RECOMMENDATION FOR CONSTRUCTION IN CREEK DRAINAGE AREA

DATE: February 10, 2021
TO: Mike Wilcox, Zoning Administrator
FROM: Ryan C. Kump, P.E., City Engineer *Ryan Kump*
Tyler Shelley, P.E., Flood Plain Administrator *Tyler Shelley*
SUBJECT: Project Name: Pepperwood 10C - Piping Creek
Plan Case Number: MISC-01-21-5982
Project Address: 12 Cobblewood Cove

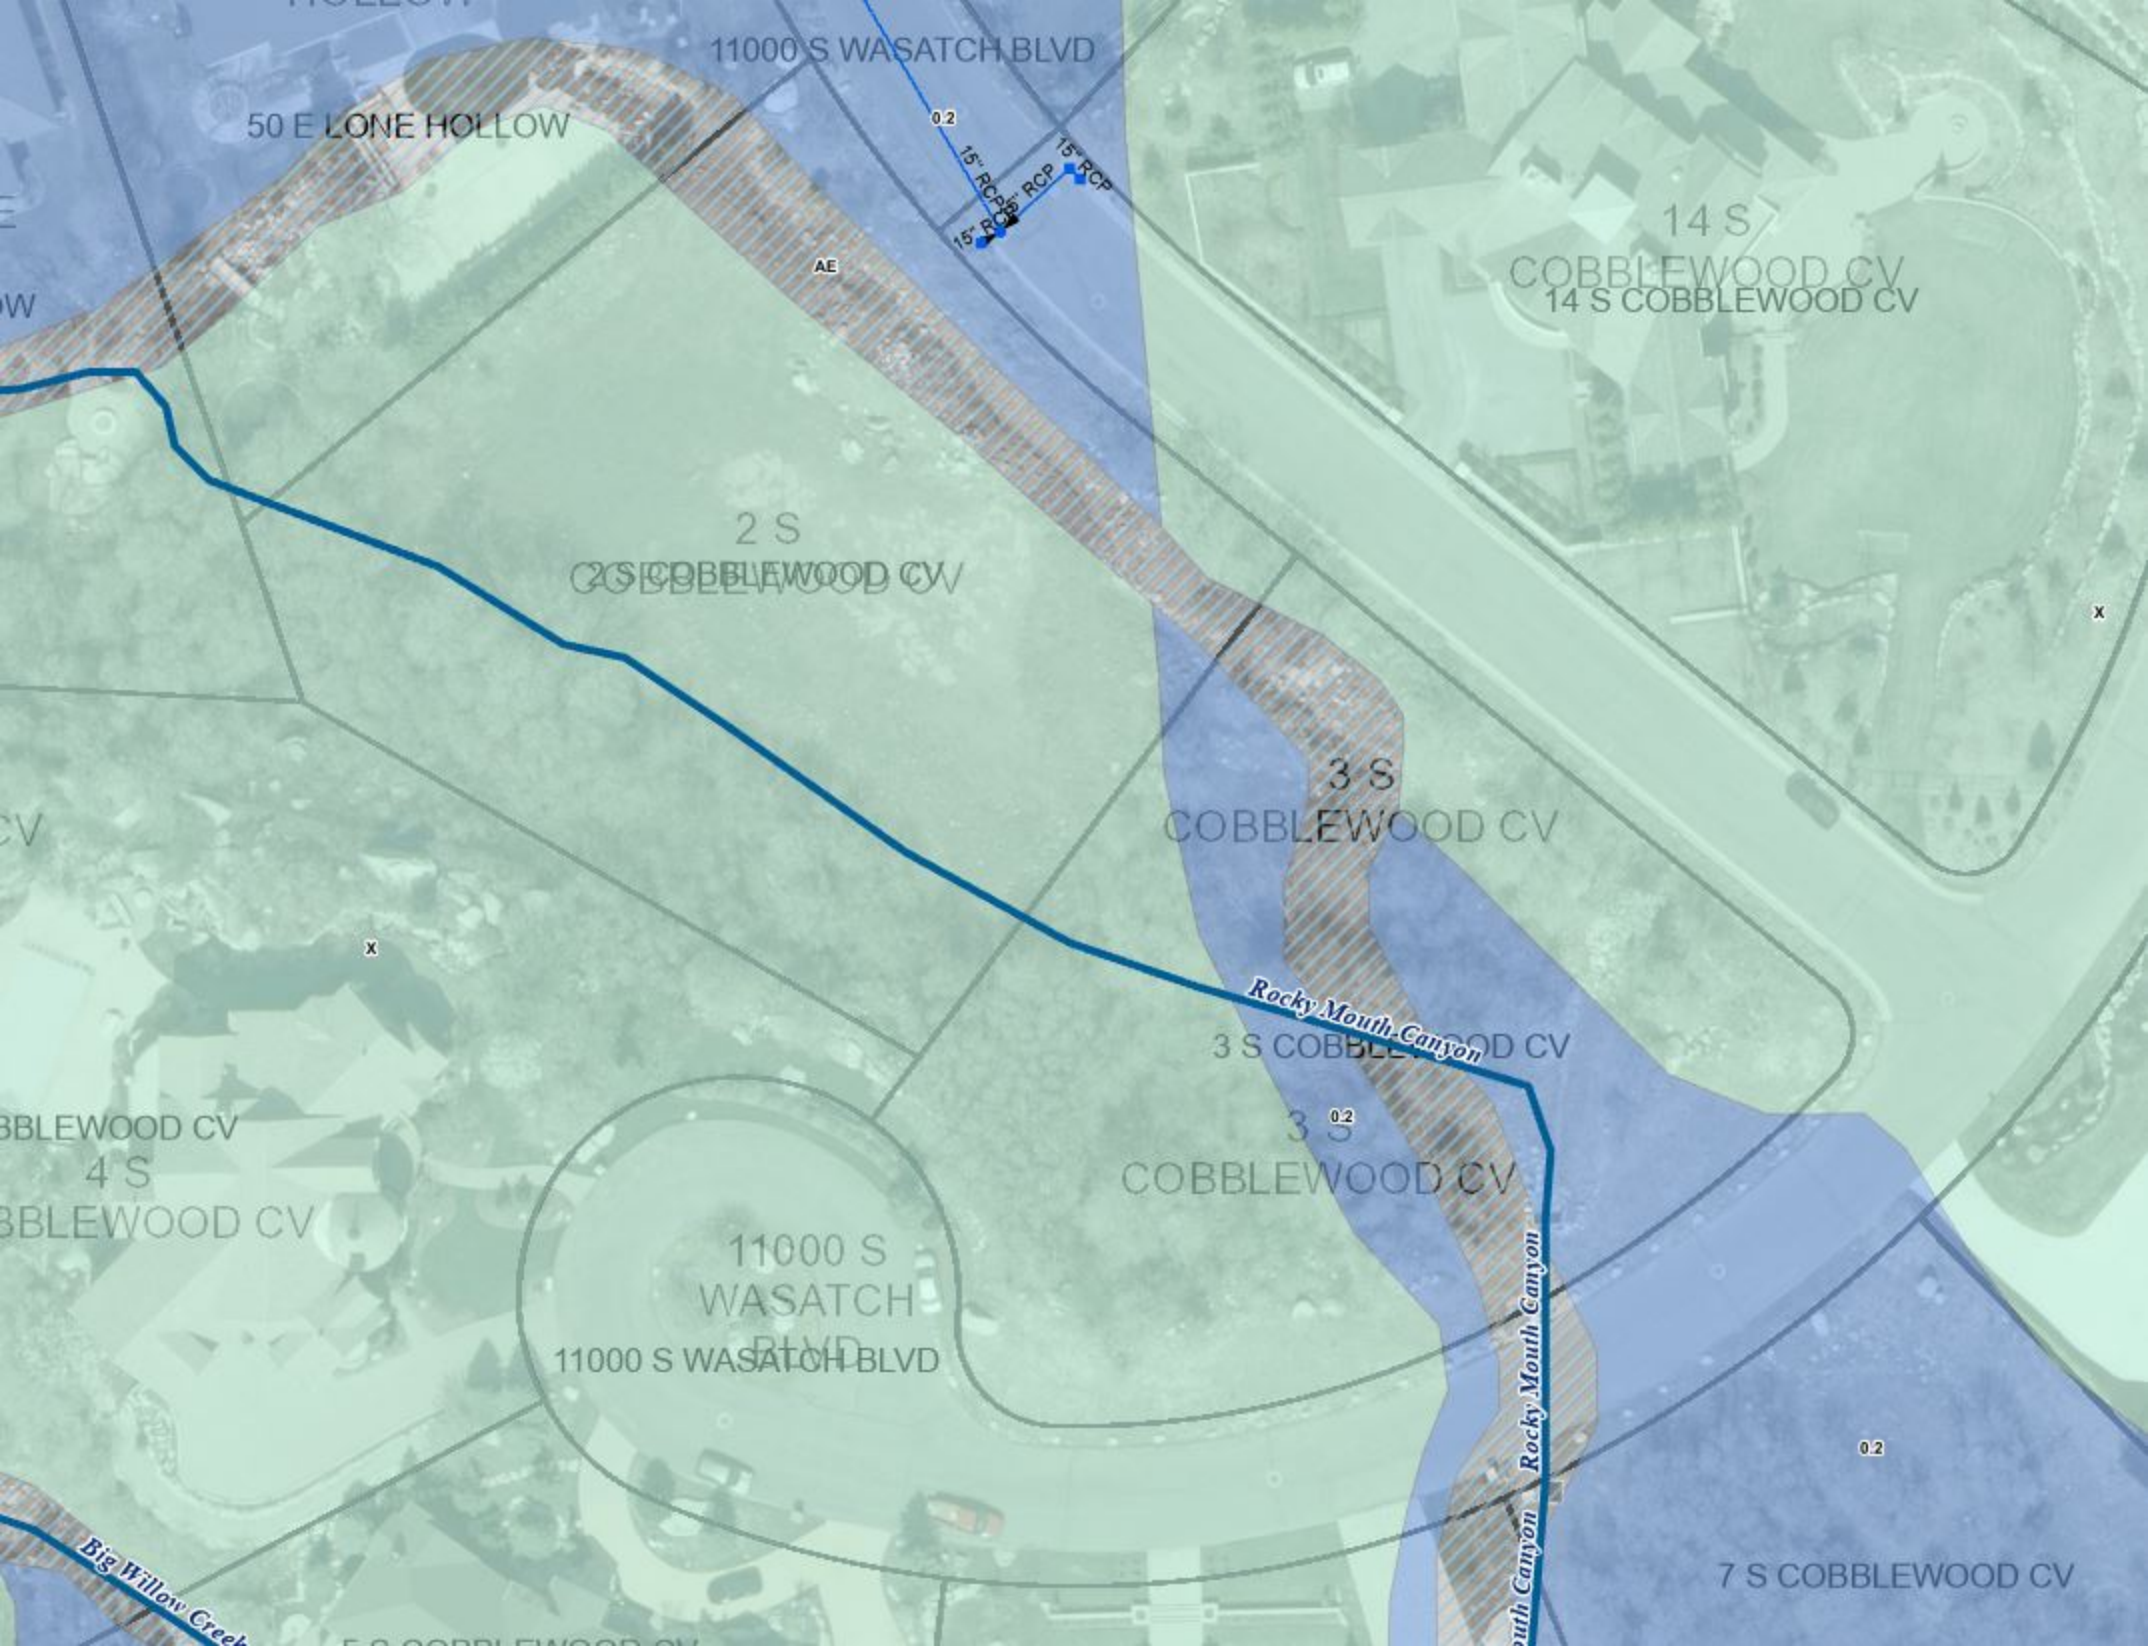
FEMA allows structures to be constructed within the 100-year *floodplain*, but not 100-year *floodway*, as long as the structure meets certain requirements. Attached is an image showing both the floodway and floodplain. The proposed homes on these two lots are located within the *mapped* floodway, but not located within the *actual* floodway, as the FEMA maps do not represent actual creek conditions.

Staff has been working with the developers of these lots with options to update the FEMA mapping, which requires a Letter of Map Revision (LOMR) application and approval by FEMA. Due to existing conditions, with previous piping that has occurred upstream of these two lots, the mapping for this creek needs to be redone for its entirety. Staff has determined that it would be too burdensome to require the developer to do the full LOMR, as is needed. Sandy City Public Utilities has committed to completing the remapping effort. The proposed piping within these two lots will be sized to meet the full 100-year flow as determined by FEMA.

It is recommended that Planning Commission grant a waiver for construction within Creek Drainage Area, due to the conditions as listed above.
